# Addendum No. Two

RFP No: FY24-805-45 A

Airport Terminal Building Improvements AWIP : BHS-TC2/TC4 : A-Wing Offices

This Addendum # 2 to Request for Bids for Airport Terminal Building Improvements AWIP : BHS-TC2/TC4 : A-Wing Offices contains the following responses to bidder inquiries and clarifications or changes to the Bid Documents:

DATE:
 05/24/2024
 M4.101

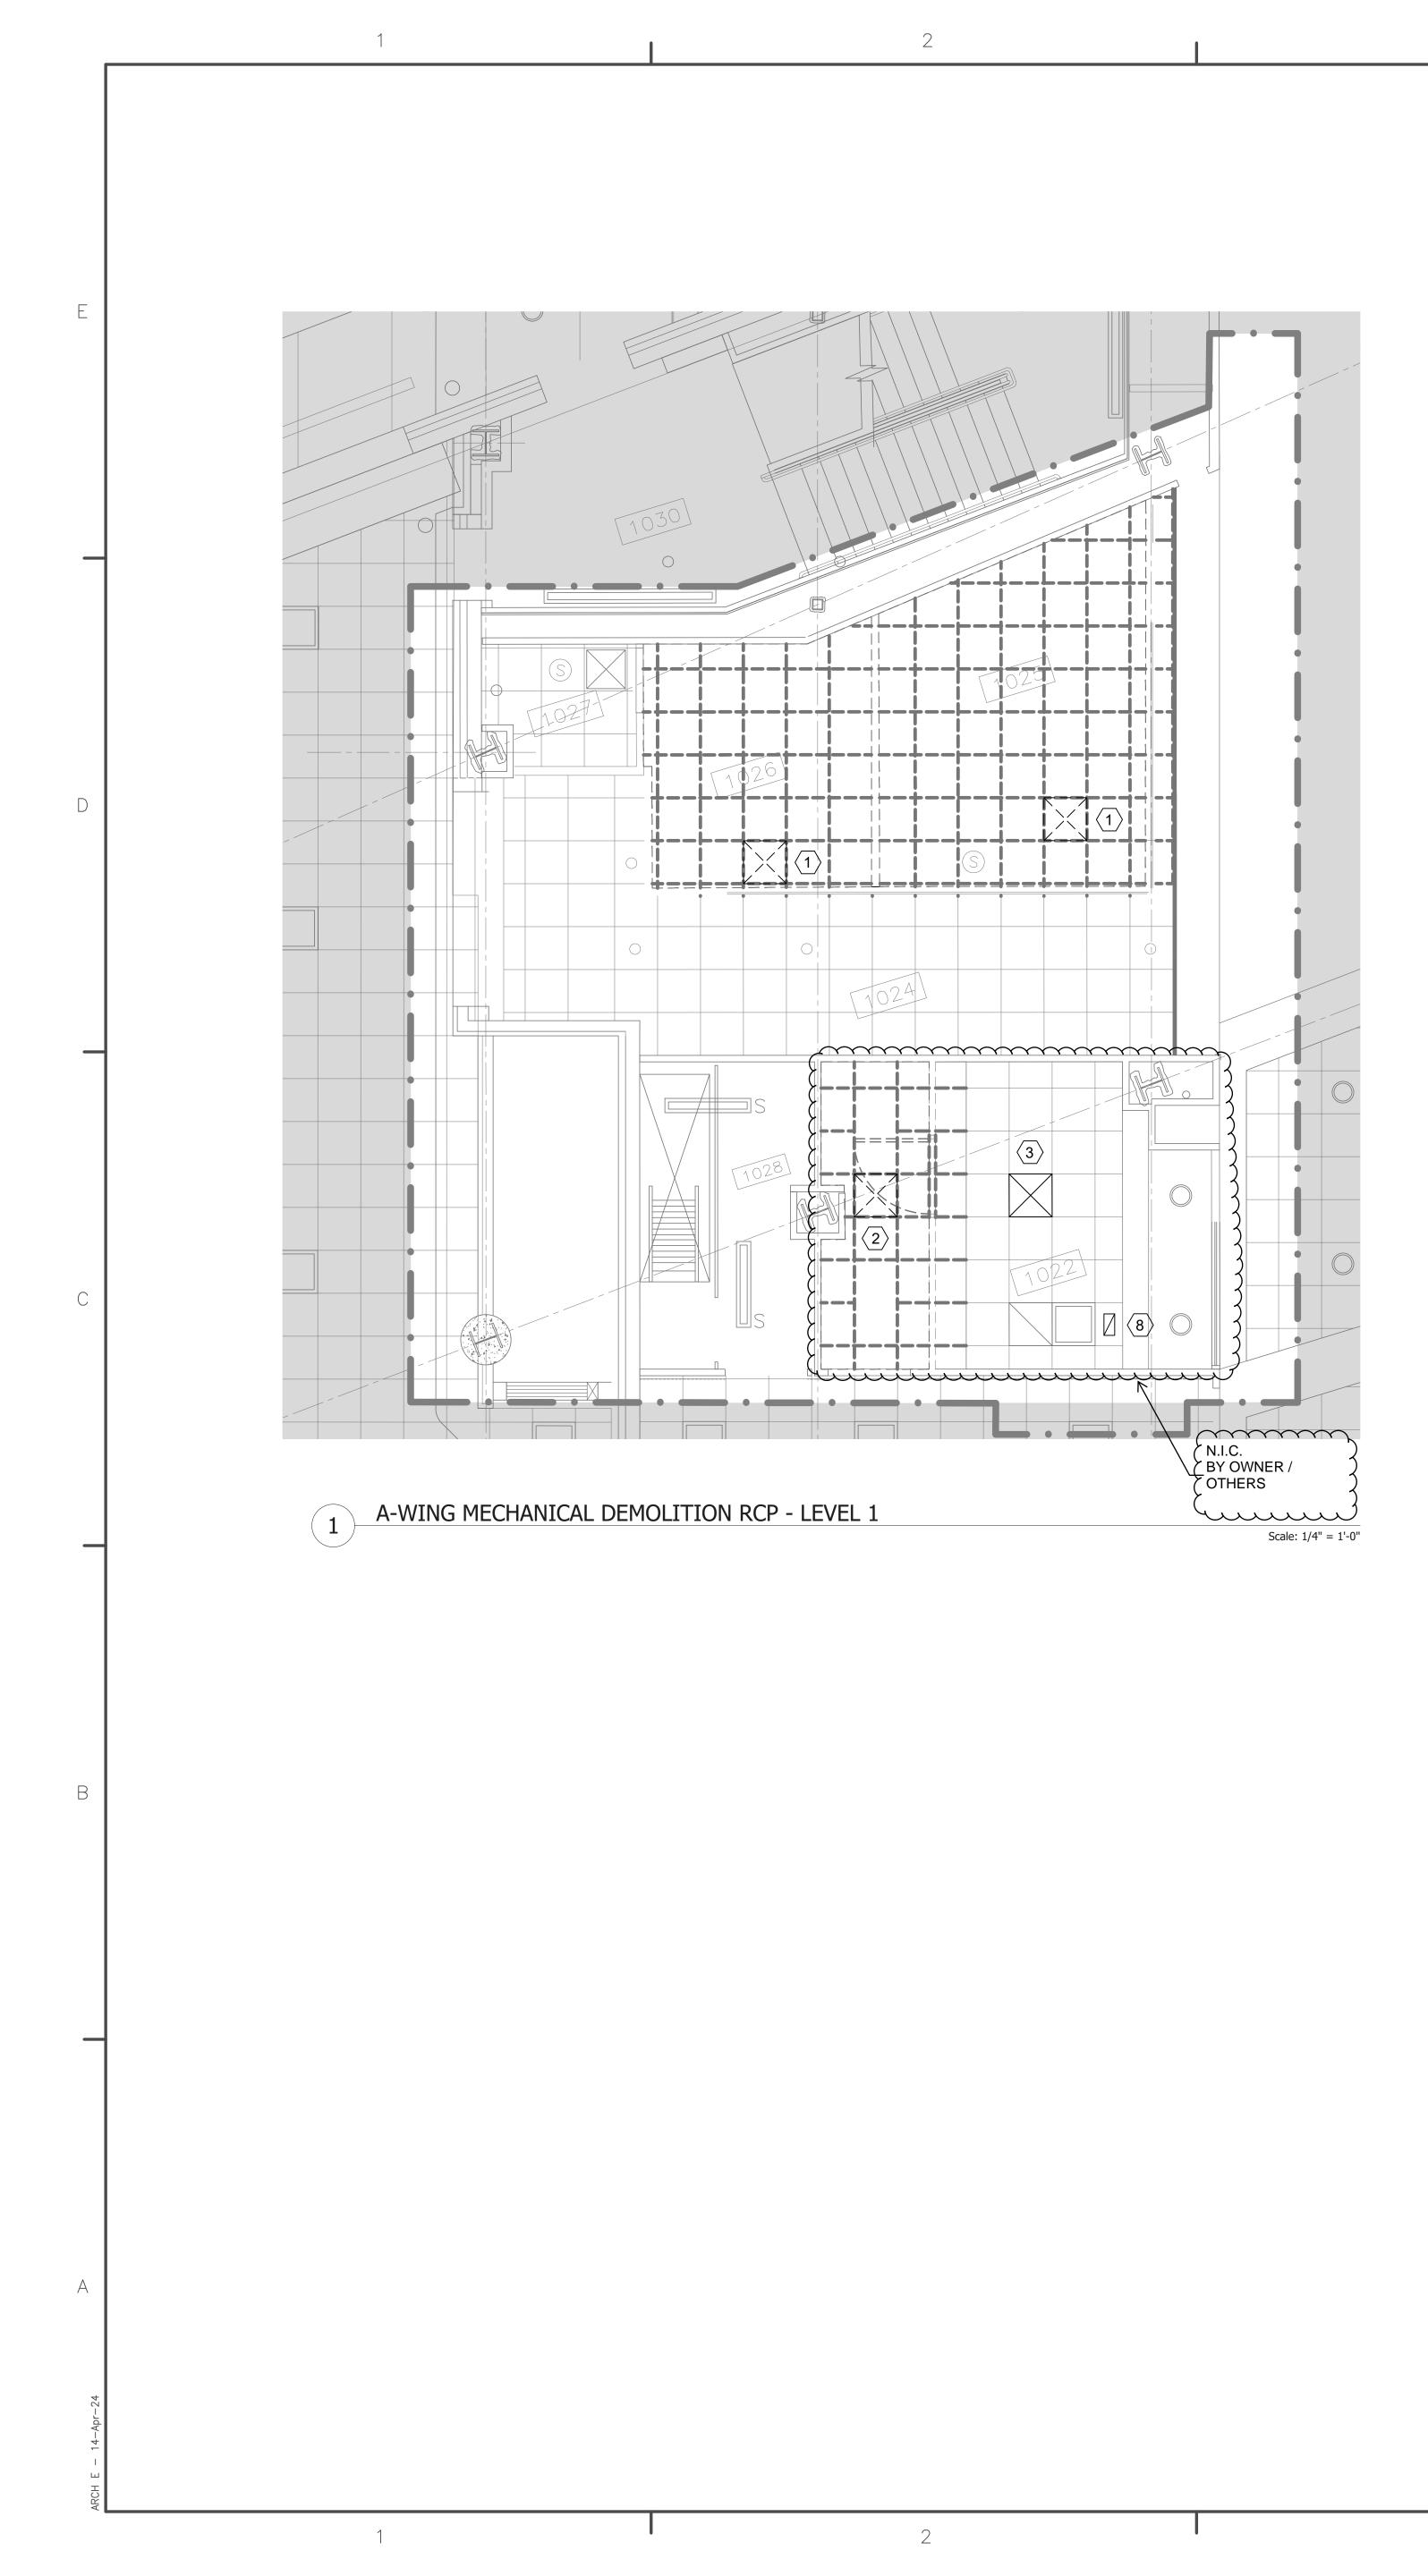
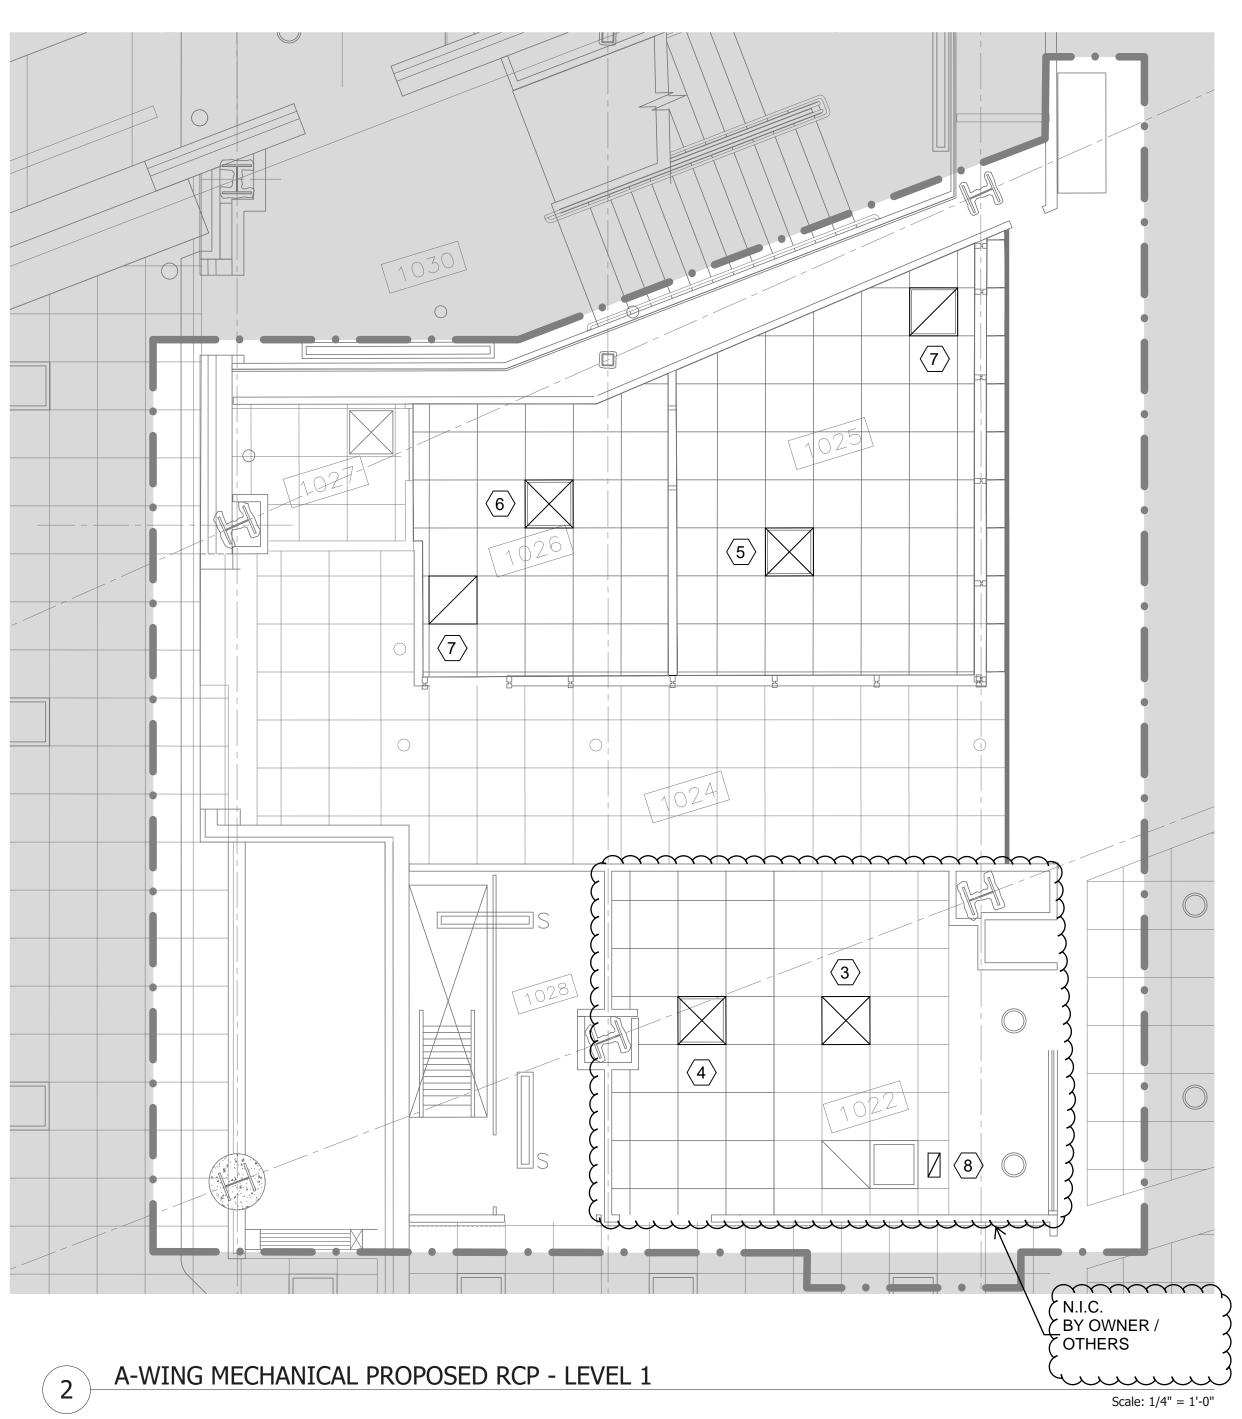
EXISTING WALL MOUNTED THERMOSTAT TO BE RELOCATED.
 RELOCATED WALL MOUNTED THERMOSTAT. PROVIDE ALL REQUIRED CONDUIT AND WIRING.
